APPLICATION NO.	FILING DATE	FIRST NAMED INVENTOR	ATTORNEY DOCKET NO.	CONFIRMATION NO.
10/670,168	09/25/2003	Gil M. Vardi	S63.2H-12012-US01	2222
23552	7590	09/18/2007		
MERCHANT & GOULD PC P.O. BOX 2903 MINNEAPOLIS, MN 55402-0903			EXAMINER HOUSTON, ELIZABETH	
			ART UNIT 3731	PAPER NUMBER
			MAIL DATE 09/18/2007	DELIVERY MODE PAPER

Office Action Summary

DETAILED ACTION

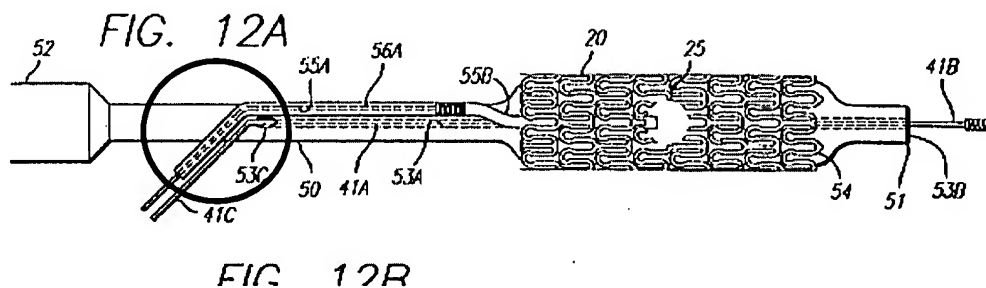
7. Claims 1-4, 13-19 and 21-22 are rejected under 35 U.S.C. 102(b) as anticipated by or, in the alternative, under 35 U.S.C. 103(a) as obvious over Wilson (EP 0 897 700).
8. Wilson discloses catheter system for positioning a stent at a vessel bifurcation substantially as claimed (see entire document). Specifically, Wilson discloses a catheter

(Fig 12a-c) comprising a channel (53a) having a main guidewire lumen extending from a distal end (51) to a main exit port (53c) located at a first distance. There is a branch guidewire enclosure (55a) extending proximally from a side opening (25) of a stent (20) to a branch exit port (see for example 56c) located at a second distance. The branch guidewire enclosure is coupled to the channel adjacent (or near, close to) the branch exit port. The first and second distances of the exit ports are less than a distance from the proximal end to the distal end of the catheter and greater than a distance from the distal end of the catheter to the proximal end of the stent. The device has a balloon (54) and an inflation portion for inflating the balloon. The catheter comprises a bond portion (indicated by circle - see below) that connects the main exit port, the branch exit port and a proximal tube.

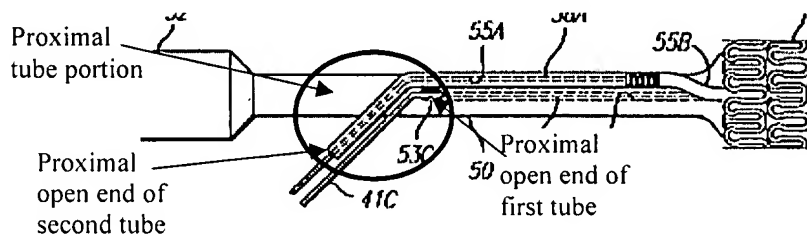
11. Regarding claim 13, Wilson discloses a catheter with a proximal tube *portion* and a distal *portion* comprising a first tube (53A) with a proximal open end (53C) and a second tube (55A) with a proximal open end (for example 56C). There is a bond *portion* that connects that proximal tube *portion* with the distal *portion*. The bond portion has a three-way bond that couples the proximal tube portion to the proximal open end of the first tube and the proximal open end of the second tube.

12. The first/main guidewire lumen/tube is attached to the branch/second lumen/tube external of the bond portion. The bond portion is located at a predetermined distance proximally from a proximal portion of the stent. The proximal tube portion connects to the bond at a distance from where the distal portion connects to the bond. The first and second guide wires exit at the bond portion.
